FOI reference: 24-101

Freedom of Information Request - Reference 24-101

From: [Hubbard, Benjamin](#)
To: [Bunnik, Chris](#)
Cc: [Poon, Kit](#); [Rampton, Tim](#)
Subject: RE: Euree/Limestone/Treloar - RG 19038-3/1
Date: Thursday, 12 October 2023 10:40:20 AM
Attachments: [image005.png](#)
[image006.png](#)
[image007.png](#)
[image008.png](#)
[image009.png](#)

Site: 101 [Limestone Av_Treloar Cr_Euree St_AM (Site Folder: General)]

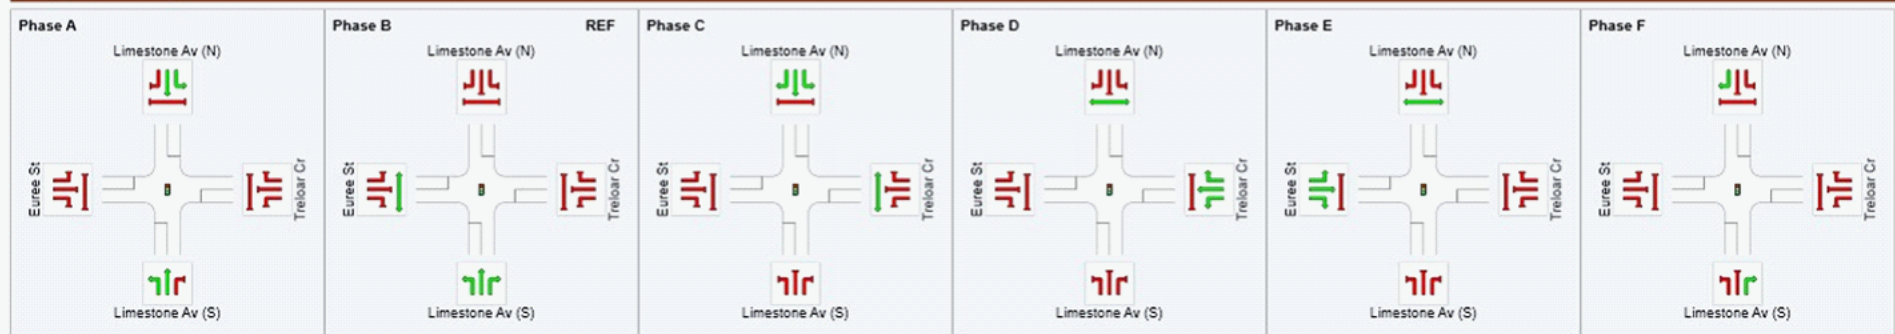
The phasing summary suggests a phase sequence of ABCDEF:

As we know, this phase sequence is impossible to operate considering standard traffic signal operation in Australia. The overlaps are non-complimentary from a phase to phase basis and the sequence suggests that the pedestrian across Limestone Avenue can operate in D and E phases. Furthermore, the pedestrian operating across Euree and Treloar during B and C phases when overlapping from A phase constitutes an illegal movement as the pedestrian may introduce whilst vehicles are streaming during the intergreen overlap from the previous phase.

Permitting the pedestrians to operate in both D and E phases overall reduces the delay to the main Limestone Avenue movement as the 31 second pedestrian operation can be split between two phases, instead of over one phase.

This original model suggested a 95th percentile queue of 811m with an average speed of 17km/h and an average delay of 135.4s. Note that the cycle length in the original model was configured as 150s a cycle length higher than any in the Territory (this cycle length would reduce the overall delays in the model).

Site: 101 [Limestone Av_Treloar Cr_Euree St_AM - Fixed (Site Folder: General)]

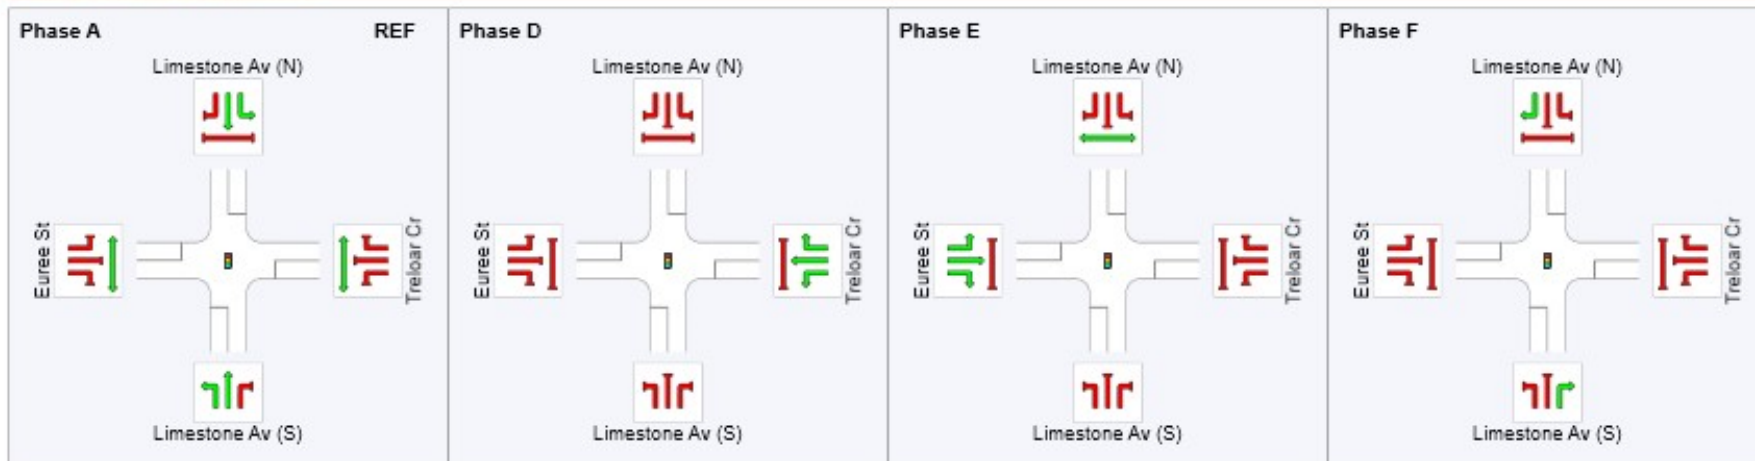
I have now modified the SIDRA model provided to correct the phase sequence and the pedestrian operation as seen below:

With the updated modelling parameters including pedestrian movement/phase sequence, the model now suggests that the 95th percentile queue in the AM peak is 1384m (compared to 811m) with an average speed of 9.1km/h (original model 17km/h).

The average delay has increased from 135.4 seconds to 333.6 seconds.

This queue length and delay suggested in the updated model more closely compares to the current AM peak scenario with excessive queueing on Limestone Avenue.
